PCN #: 2800

PCN Title: Fab Porting from SK keyfoundry Fab3 to SK keyfoundry Fab4, Cheongju, South Korea, and Product Marking Change

PRODUCT CHANGE NOTICE

PCN-2800-REV1

Table 2A – Top Marking Change

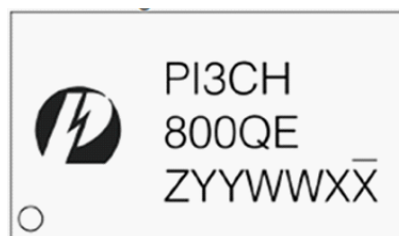
Current Marking

Z: Fixed Code
YW: Date Code (Year & Work Week)
G: Assembly Site Code (1st G)
G: Wafer Fab Site Code
Bar above "I" means Fab3 of MGN
Bar above 2nd "G" means Cu wire

New Marking

Z: Fixed Code
YW: Date Code (Year & Work Week)
G: Assembly Site Code (1st G)
G: Wafer Fab Site Code
Overbar Symbol: Internal Code
